Technical Service Information

4L80-E

CASE COOLER LINE FITTINGS

Figure 1

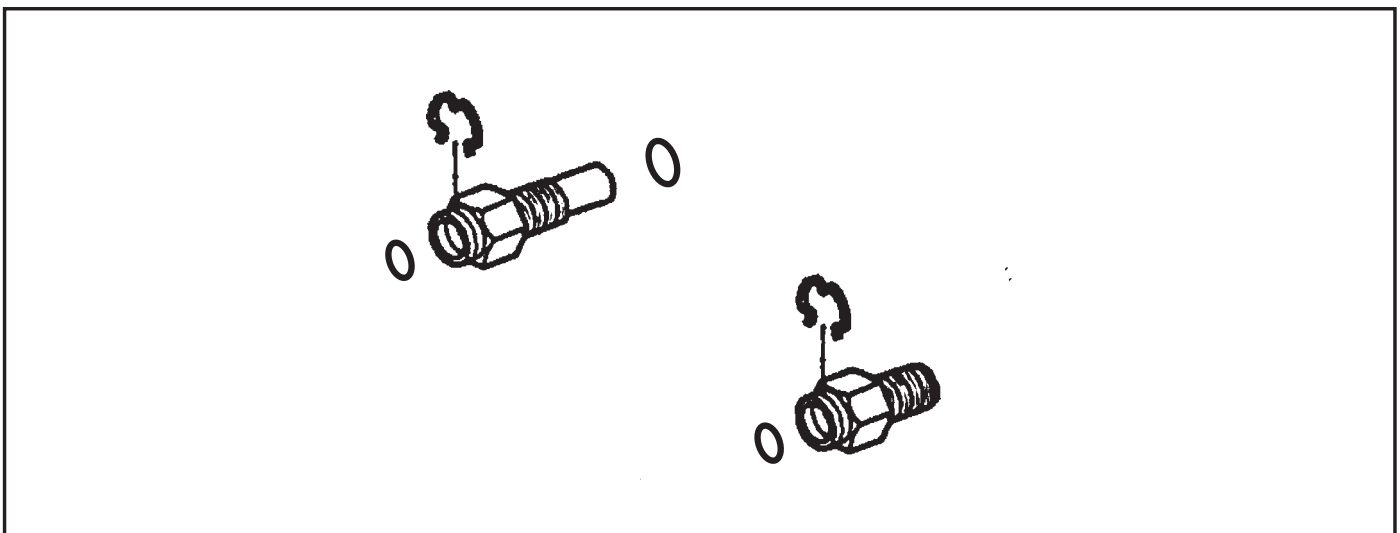
CORRECTION: 1997 and later center lube transmissions had the oil cooler return line relocated to direct oil returning to the transmission from the cooler directly into the center support at the middle area of the case instead of returning to the pump as in the 1996 and earlier units. This change also made a redesign of the case fittings necessary. The profile of the rear fitting was changed to make it longer so that the inner end will fit into a seal in the center support. At the same time, the front fitting as well as the rear fitting, was modified for quick connect / disconnect in place of the earlier flared line / threaded type. (See figure 1)

Retaining clip only - 24205103

Front fitting with clip - 24205102

Rear fitting with clip - 24207013
